NEW MEXICO
ENVIRONMENT DEPARTMENT

**RE: DISAPPROVAL
FINAL NITRATE CHARACTERIZATION STUDY REPORT, JANUARY 2014
HOLLOMAN AIR FORCE BASE, EPA ID # NM6572124422
HWB-HAFB-14-001**

Figure 1. Crossplot of typical $\delta^{18}\text{O}_{\text{NO}_3^-}$ and $\delta^{15}\text{N}_{\text{NO}_3^-}$ values for different nitrate sources and the trend of isotopic compositions obtained due to denitrification processes (modified from Clark and Fritz, 1997).

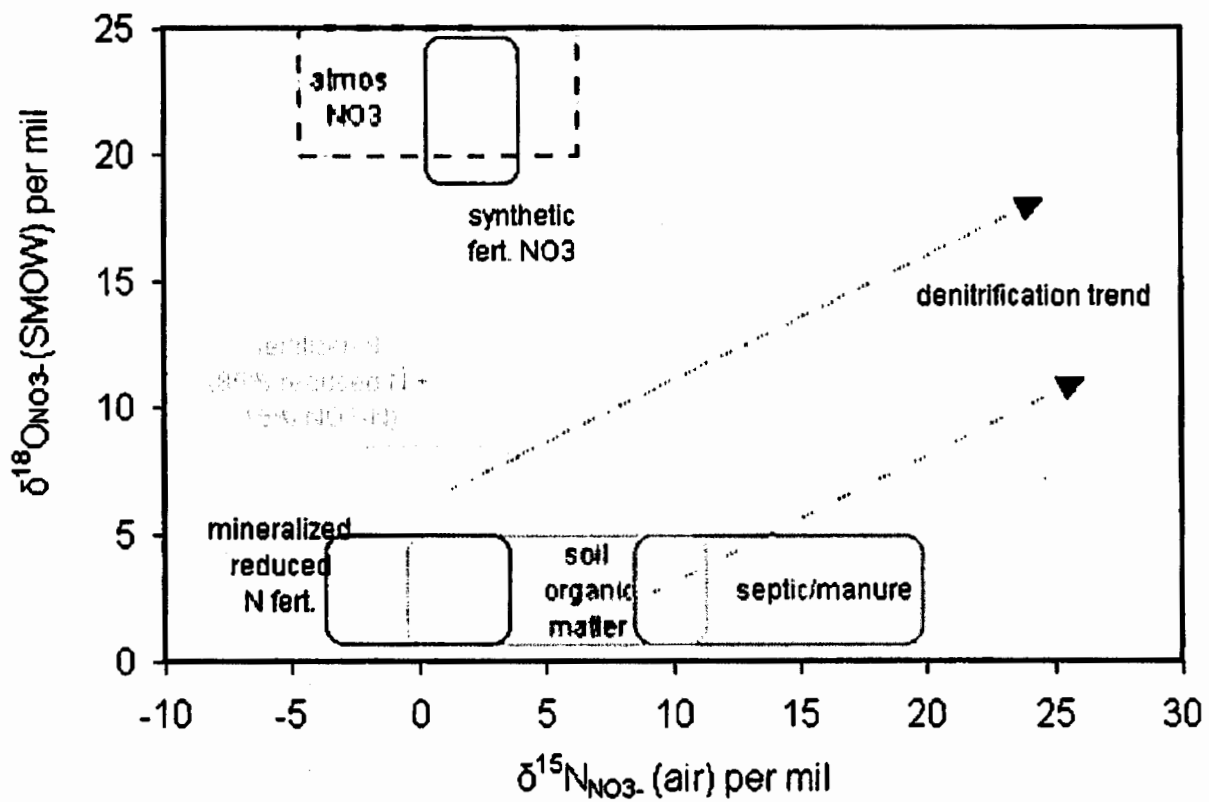
- b. Collect groundwater samples at all 24 MWs and analyze them for stable isotopes of nitrogen and oxygen (specifically $^{15}\text{N}/^{14}\text{N}$ and $^{18}\text{O}/^{16}\text{O}$). The data, in the form of $\delta^{15}\text{N}$ and $\delta^{18}\text{O}$, must be plotted on a graph similar to the one shown on Figure 1 (enclosed with this letter) to support interpretation of the data.
